# A G E N D A

## Architectural Review Board

June 23, 2020 – 5:30 p.m.

**MASTER LANDSCAPE PLAN  
WHITLEY RESIDENCE  
1859 RIDGE AVENUE**

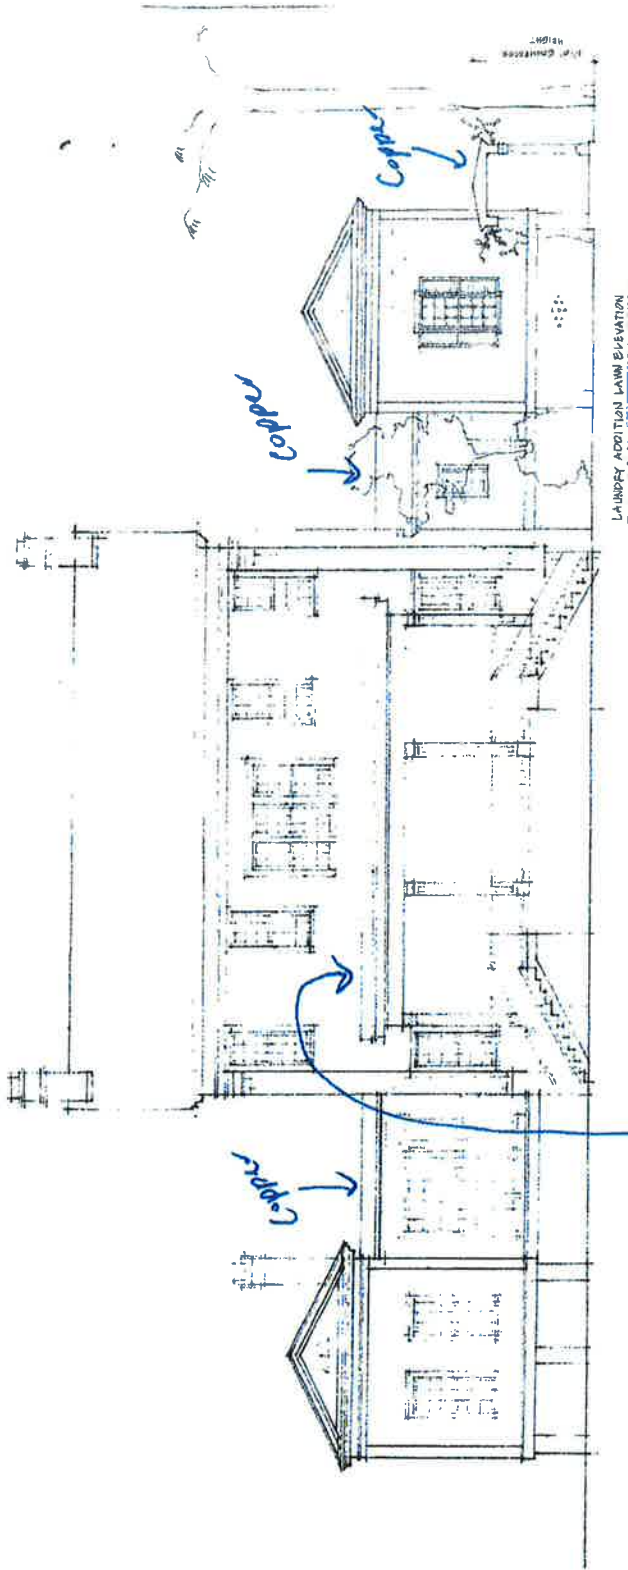
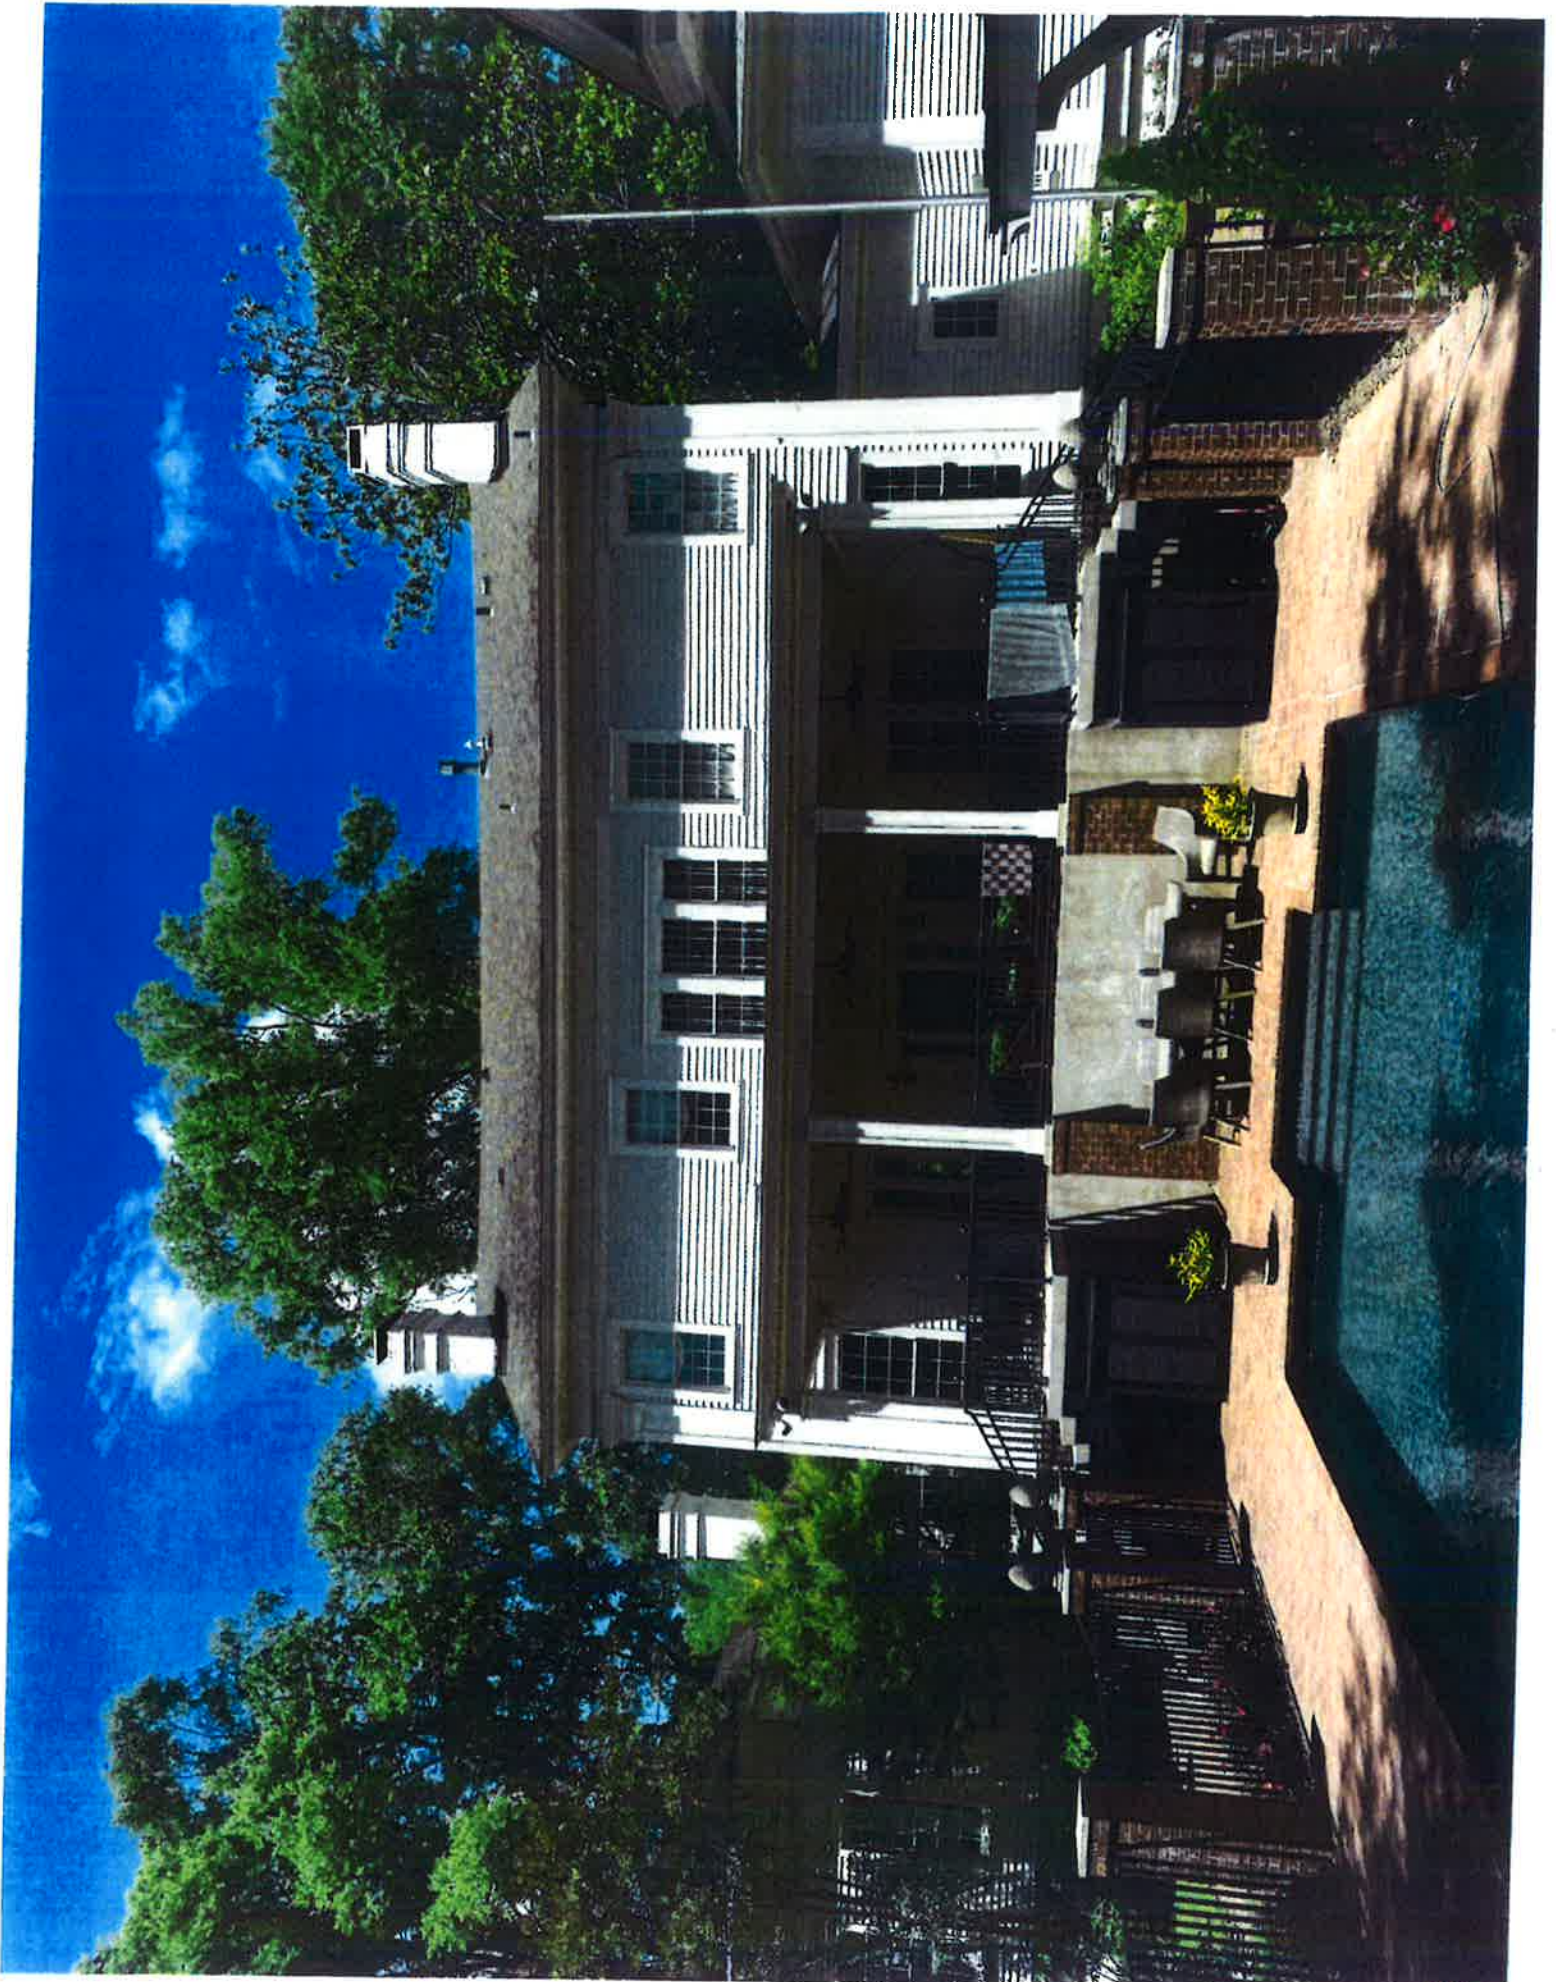
**REMARKS:** The petitioner is requesting permission to change a rear porch roof from a rolled asphalt material to a standing seam copper roof. The new roof would match all other porch roofs on the property.

- No objection.

Proposed changing  
to standing  
Seam copper  
as well

Copper on two awnings/porches on garage

# 2033 Ellen St. - Stoop Replacement

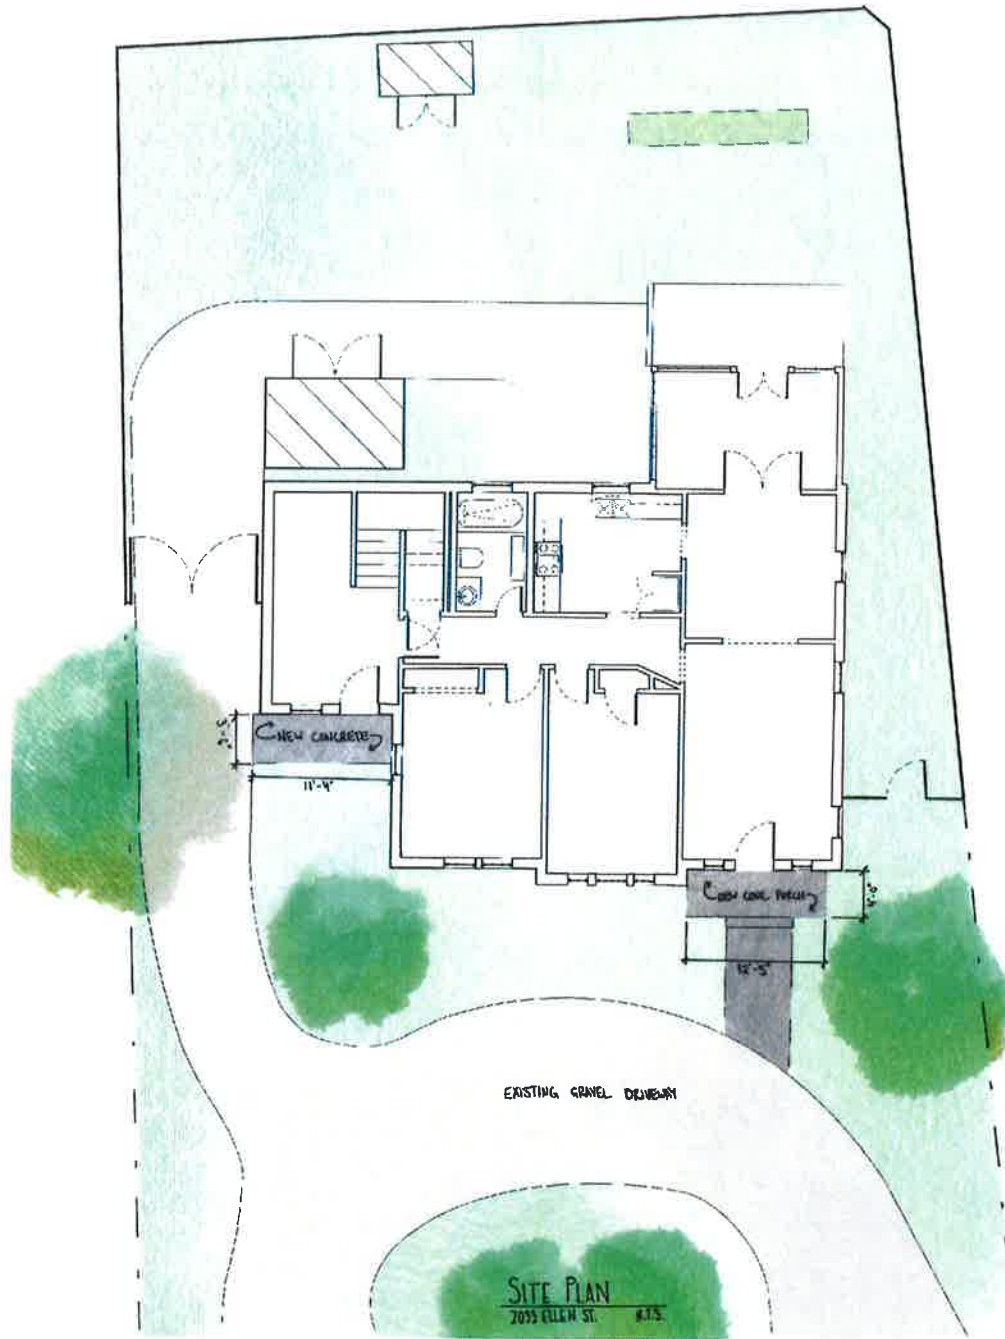
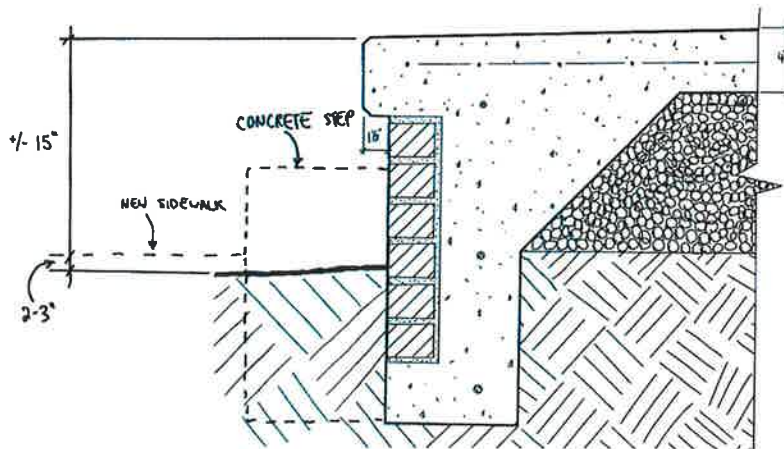
**REMARKS:** The petitioner is requesting permission to remove an existing brick stoop and replace it with a concrete stoop with a brick veneer face, and to install a new concrete walkway at the front porch and side door as illustrated. The brick veneer will match existing brick in color and texture.

- No objection.

Existing Brick Stoop

New Concrete Stoop and Walkway

1287 South Lawrence

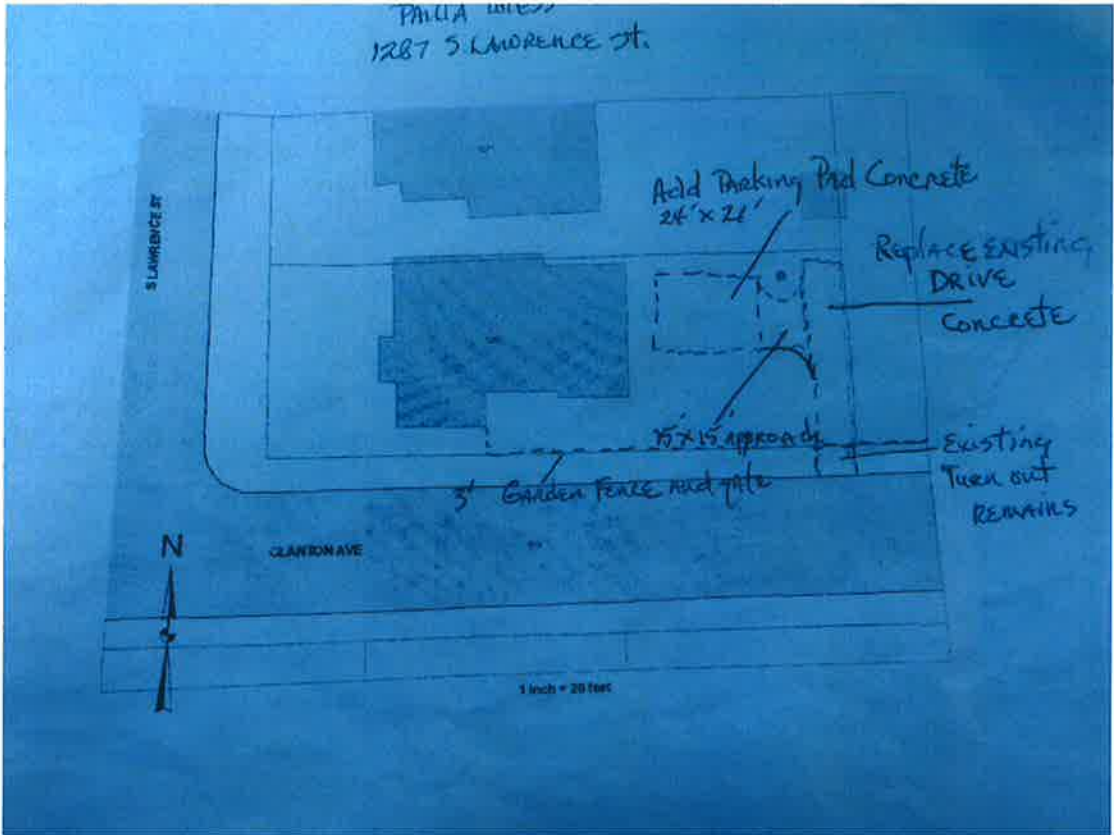
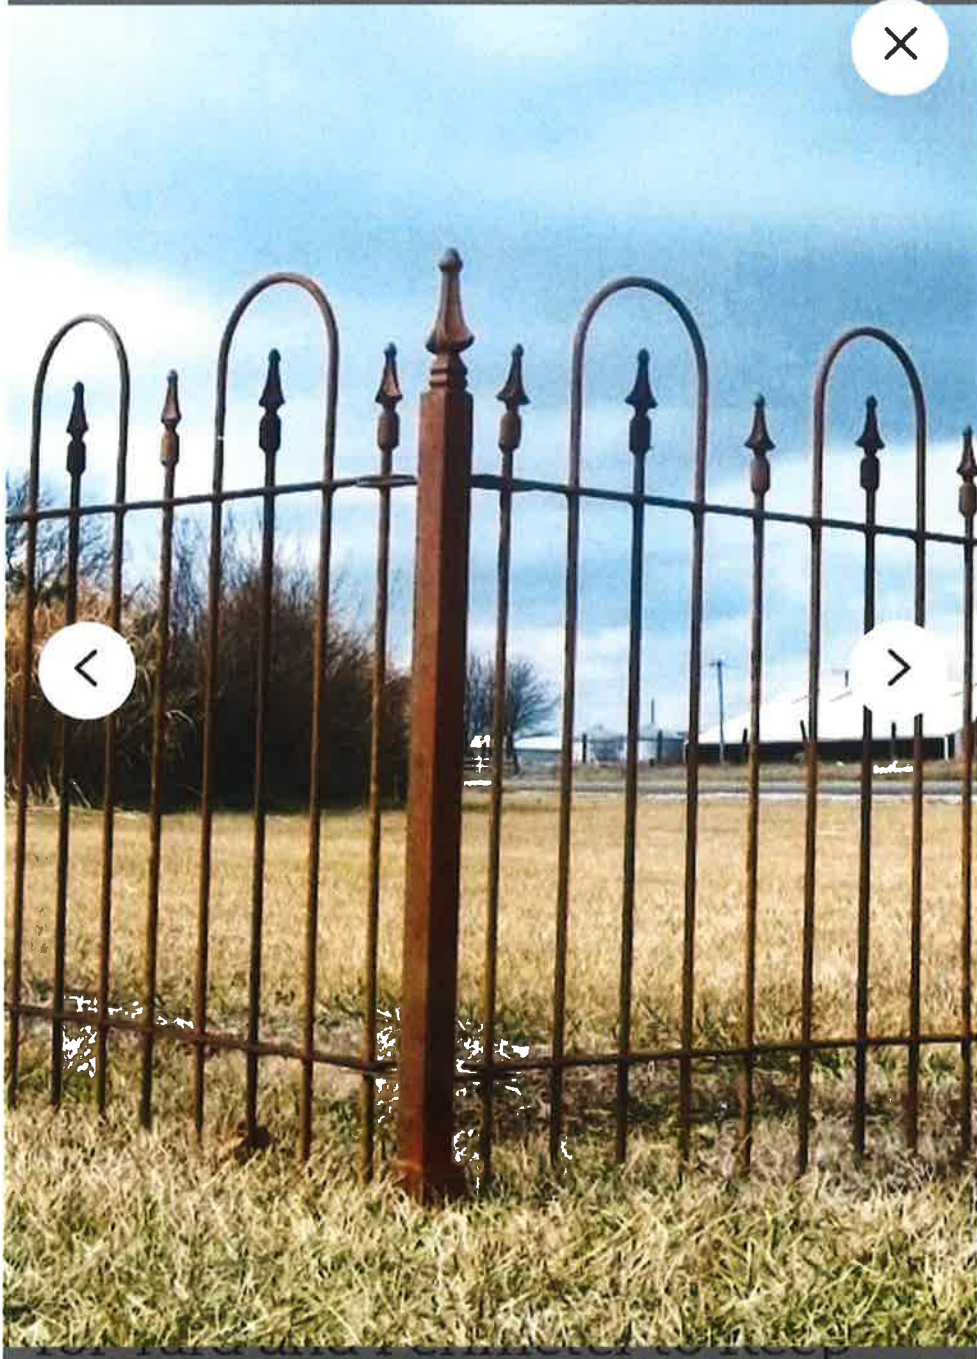
**REMARKS:** The petitioner is requesting permission to repour a failed concrete driveway, pour an addition 24’x21’ parking pad (at the rear of the house), and install an old 3’ iron fence and gates along the Clanton Avenue property line as illustrated on the site plan.

- No objection. Rear yard parking is far preferable to front yard requests.

3136 Montezuma Road

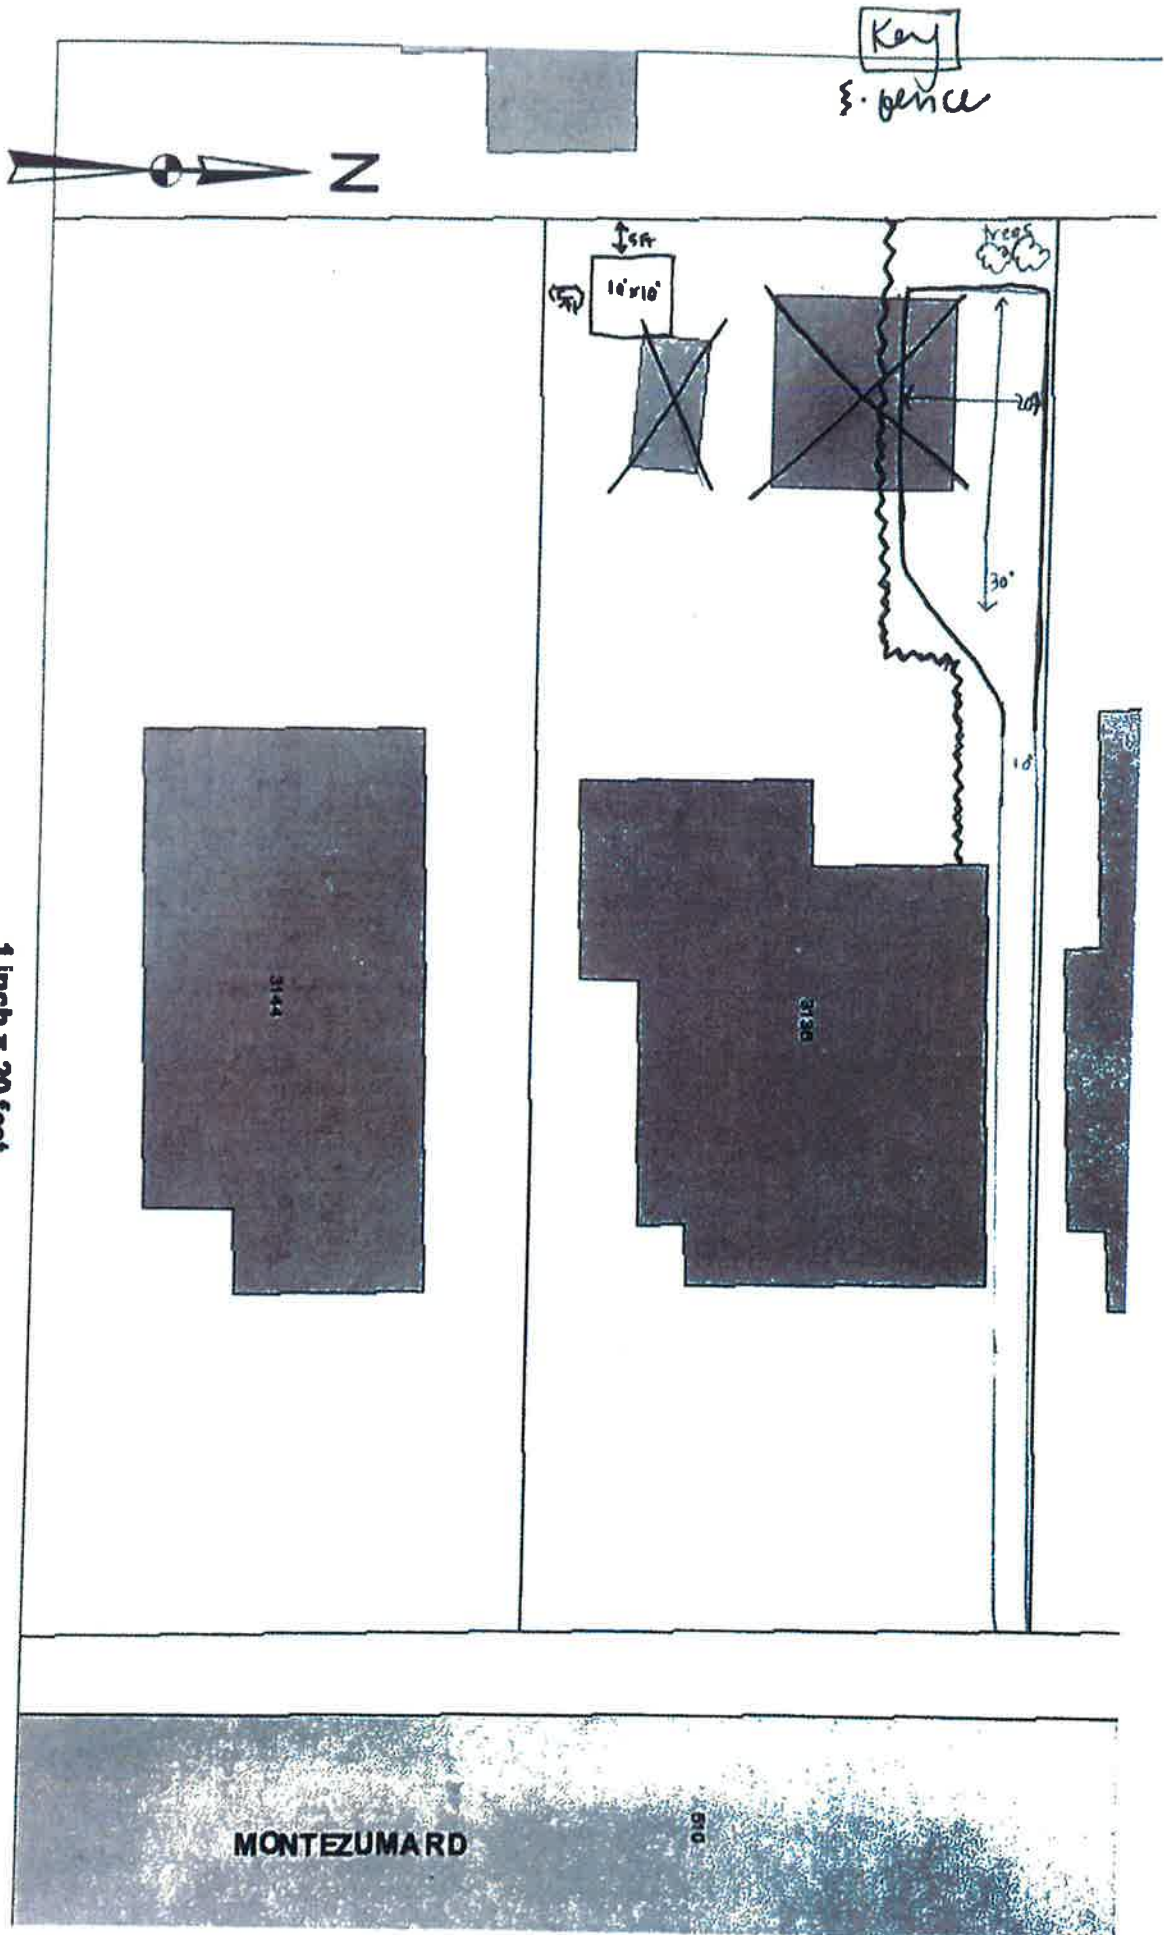
**REMARKS:** The petitioner is requesting permission to remove 2 existing sheds from the rear yard, replace the shed with a 10'x10' located in the southwest corner of the yard (meeting required setbacks) to provide more usable yard space. The shed will be painted 400-17 from the palette and roofed with shingles in Sovereign Nickel Gray. With the removal of the larger building, the petitioner would like to widen the parking area at the rear of the house, and replace the existing privacy fence with a matching fence to enclose the rear yard as illustrated on the site plan.

- Had there been no outbuildings in the rear yard, the shed would have met the expedited review requirements.
- No objection.
